N54°39.3' E024°03.5'	<h2>Technical note</h2>	Doc. No. 017.25.001
		Revision 0
		Date: 2025-10-30
"SA ir Ko" EASA.AP160	<b>Replacement of the shunt screws</b>	Page 1 of 3

**Subject:** FES system: improved screw connection of the connection cables to the shunt.

**Applicability:** LAK-17B FES – all serial numbers;  
LAK-17B FES mini – all serial numbers from sn 046 (inclusive);  
LAK-17C FES – all serial numbers from sn 309 (inclusive);

**Figure 1**

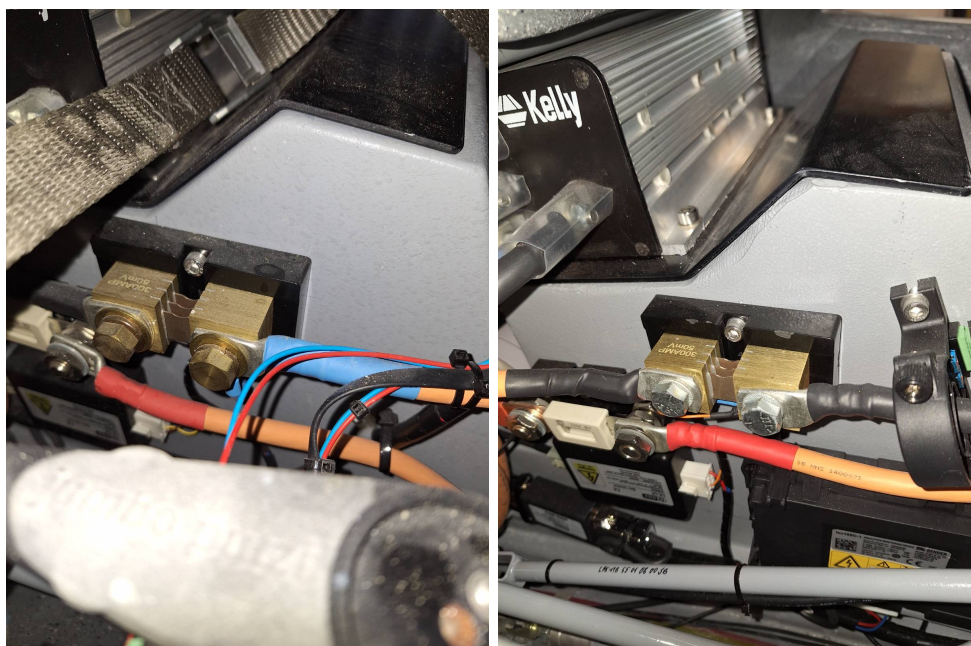
**Reason:** A shunt (small resistor) is installed in the cable between the negative pole of the battery and the controller to measure the current from the FES batteries. The screw connections of the large connection cables on the shunt were originally made with brass screws. These brass screws have torn off in several cases, possibly due to excessive tightening torque. To make this screw connection more robust and reliable, the brass screws are replaced by steel screws.

Whether the screw connection is made with steel screws (galvanised, light silver colour) or brass screws (bright brass) can be seen through the main spar window. (fig. 1a, fig 1b).

1. Verify the type of screws. The shunt is located on the left wall of landing gear box.  
If the screw connection is already fitted with steel screws, no change is to be made.
2. If the screw connection is made with brass screws, these must be replaced with steel screws in accordance with the accomplishment instructions provided in this document.

(a)

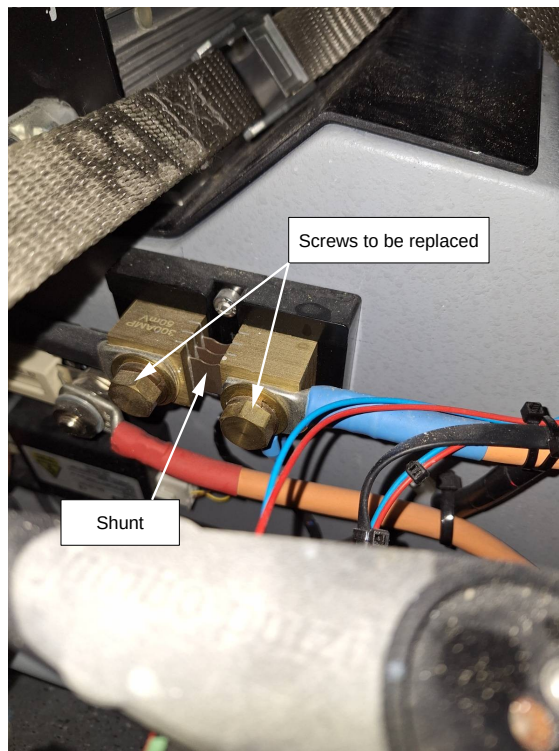
The shunt is located under the plastic cover, on the left wall of landing gear box (Fig. 2a).

After removing the plastic cover, the brass screws including the brass washers on the shunt connections can be removed. When installing the new steel screws with the new lock washers, ensure the correct orientation of the lock washer (Fig. 2b). The steel screws are additionally secured in the threaded area with medium-strength screw locking adhesive (Loctite 243 or similar). The tightening torque is 17 Nm. The plastic cover must then be refitted.
